CITY OF ST. AUGUSTINE HISTORIC ARCHITECTURAL REVIEW BOARD

A G E N D A

THURSDAY, DECEMBER 16, 2021 - 1:00 PM

Project number: 2021-0162 Project Address: 142 N. George Street
Reviewed by: Julie Courtney Date: 11.23.2021

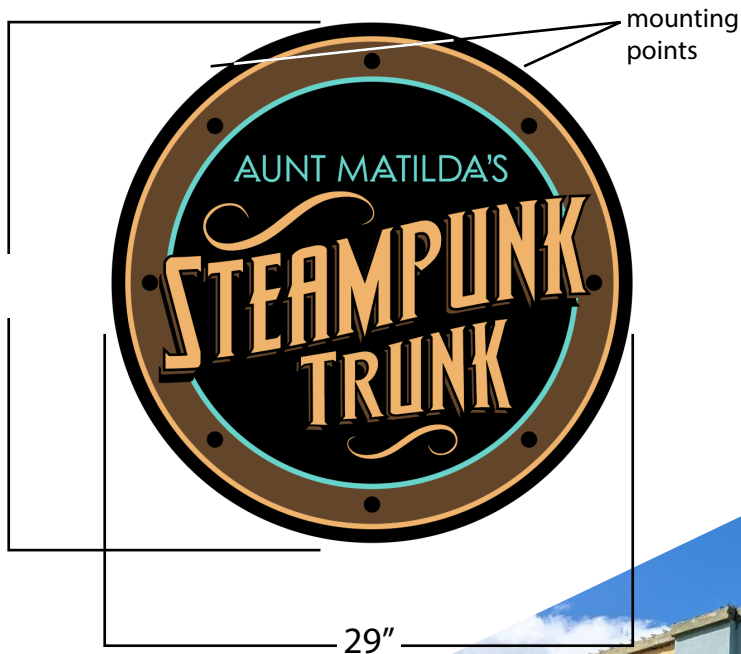
- Please provide possible alternative to vinyl graphics (that is not allowed per our Architectural Guidelines for this area)
- More photos of building & context of project would be helpful

Project number: PL 2021-0161 Project Address: 3 St. George Street
 Reviewed by: Julie Courtney Date: 11.23.2021

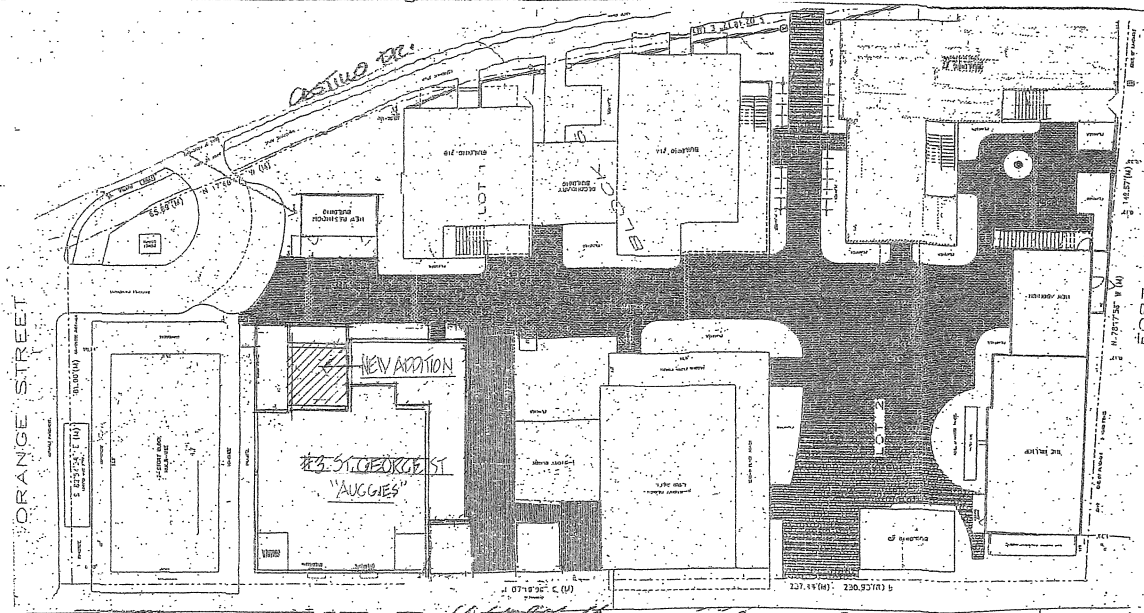
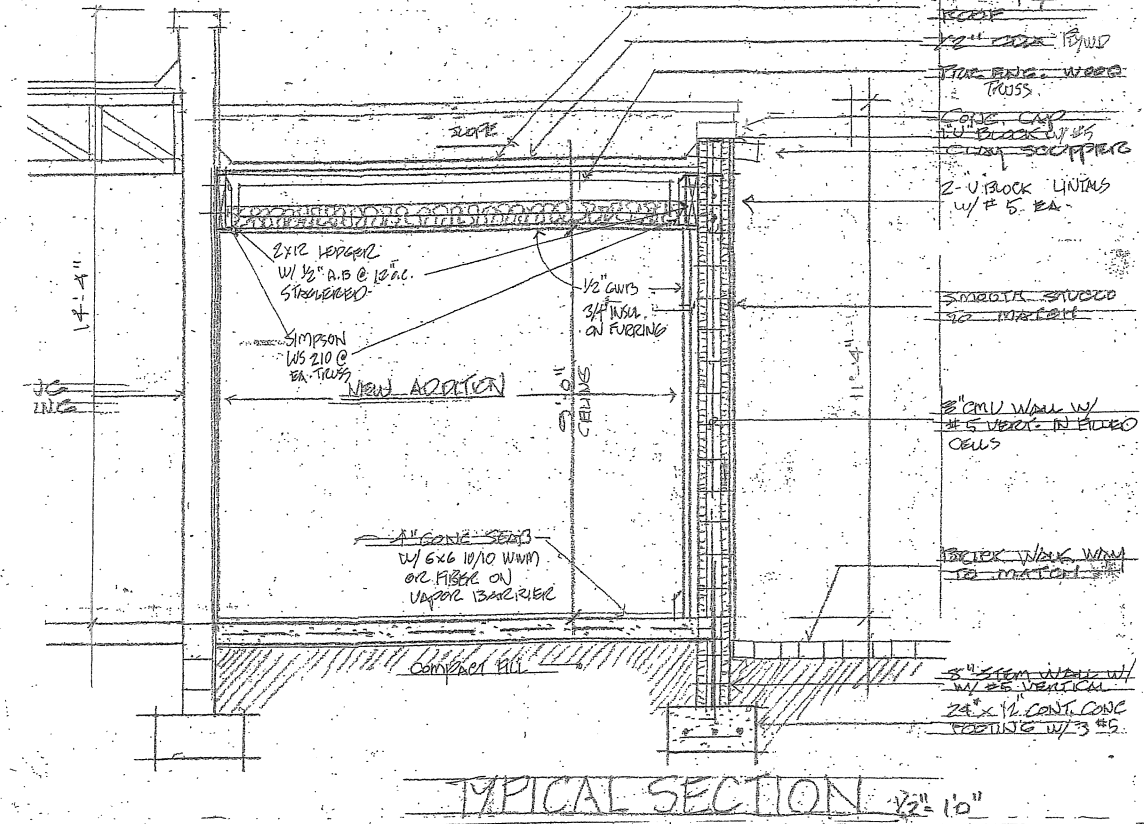
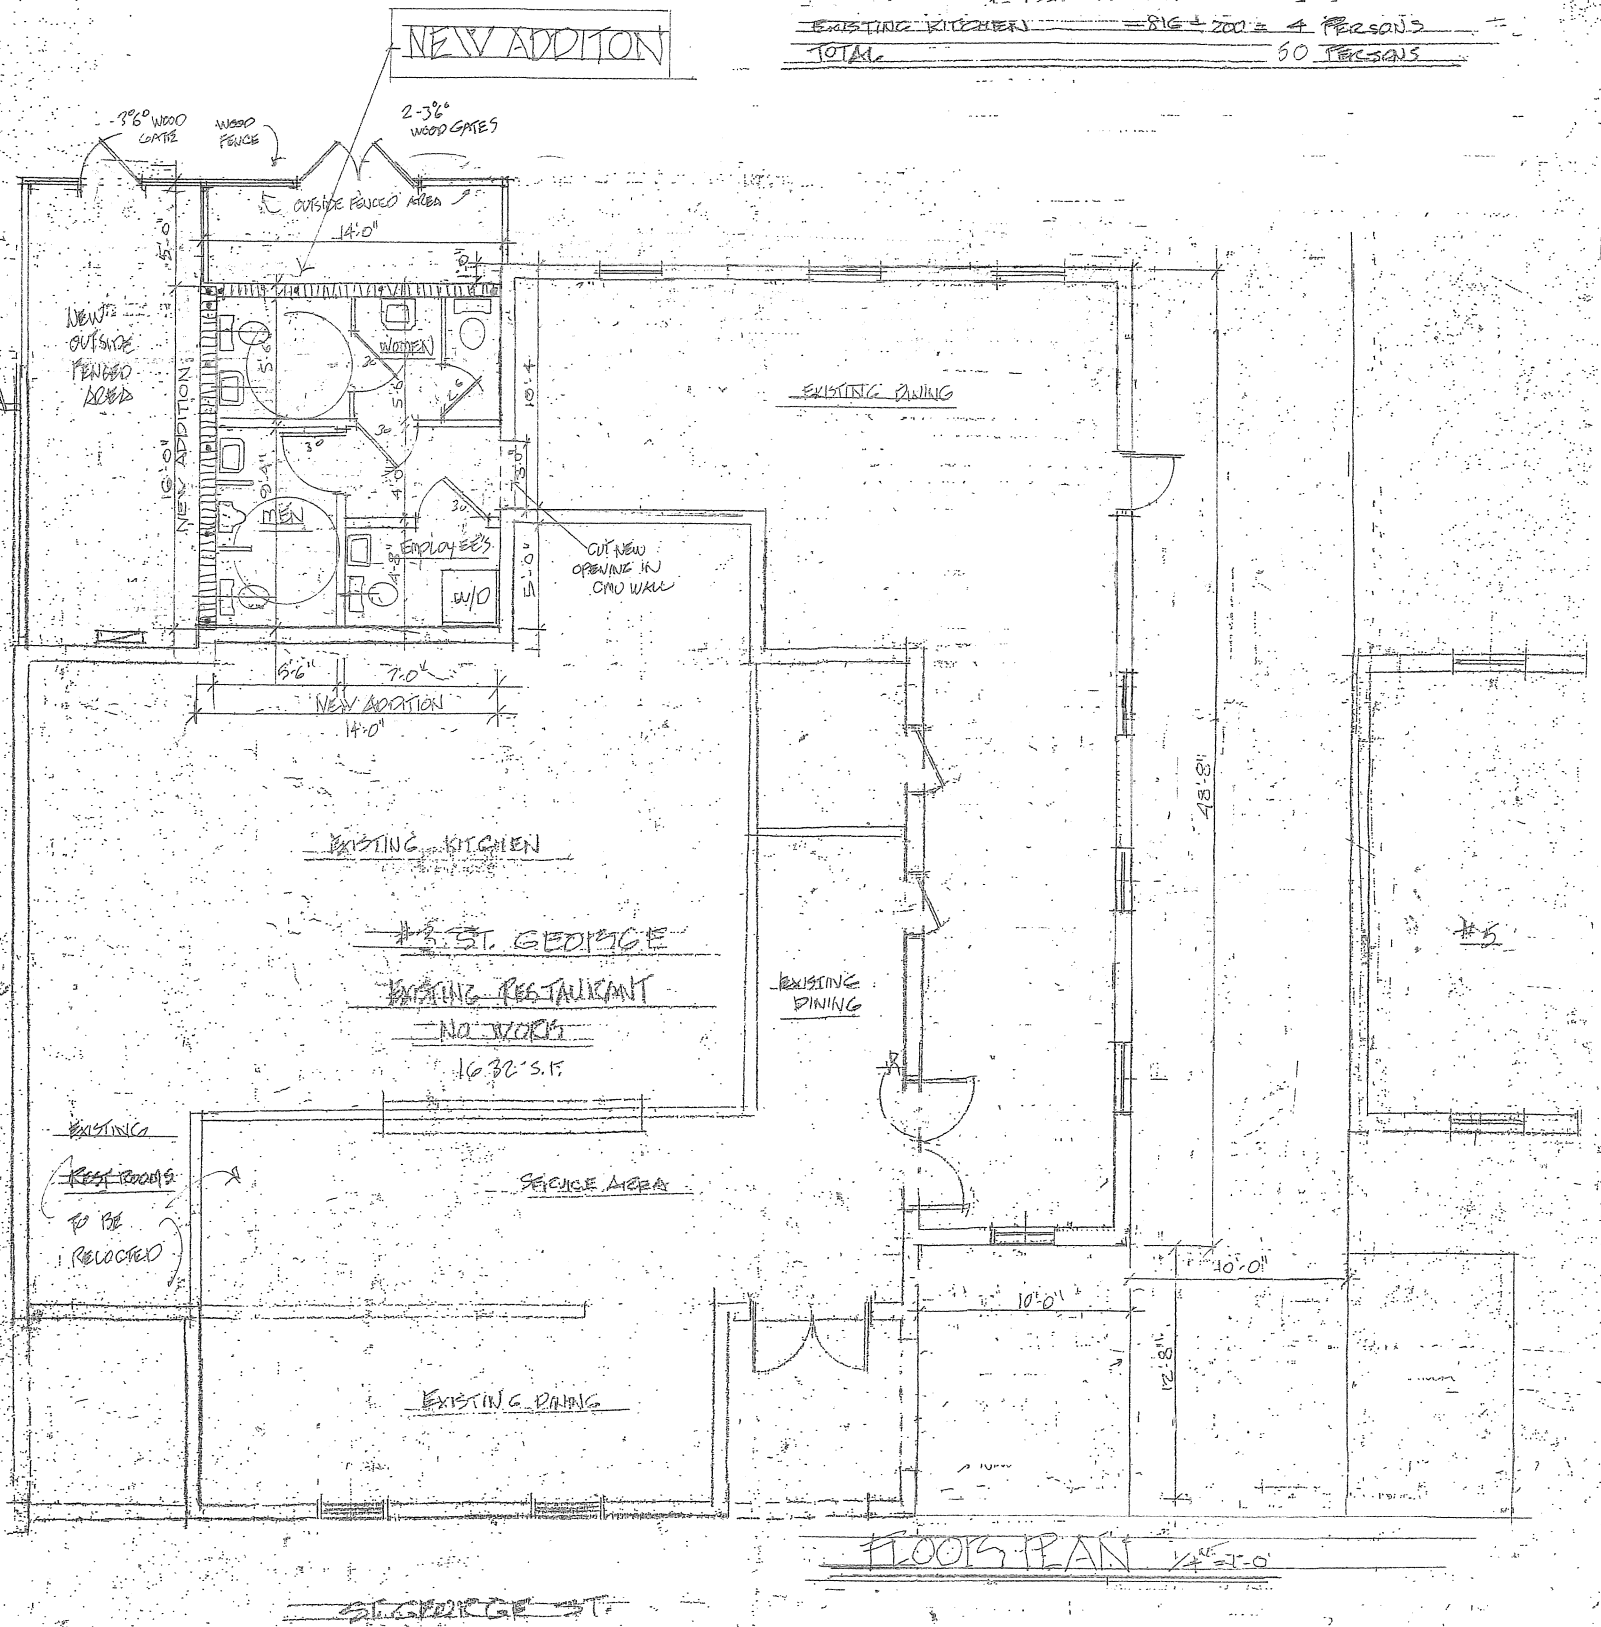
- Need more detail on fence/wall + gates if new are proposed:
- Photos and drawings of existing east elevation + north + south sides would be helpful

STAFF PHOTOGRAPHS 120 Bridge Street

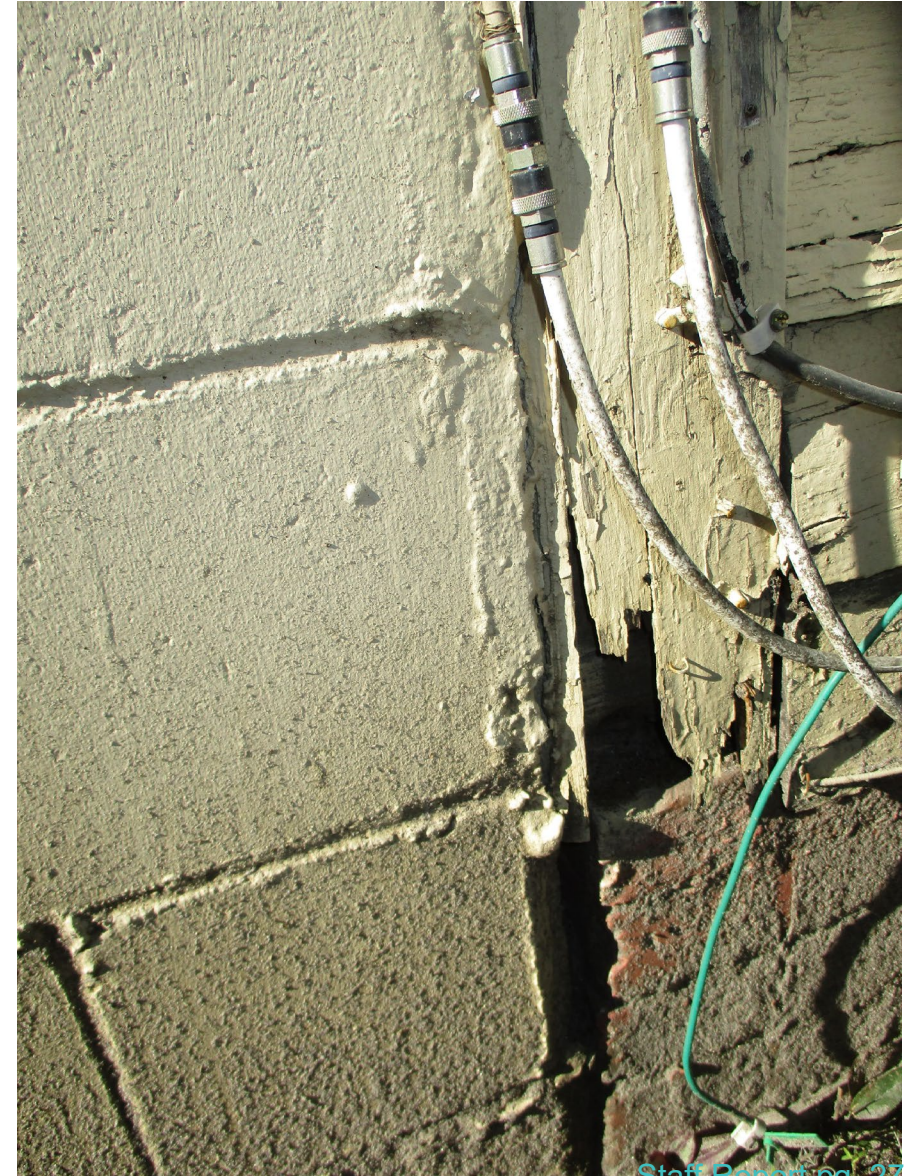
Wood windows proposed to be replaced with vinyl or aluminum in 1/1 pattern: 2/2 aluminum windows would be more compatible
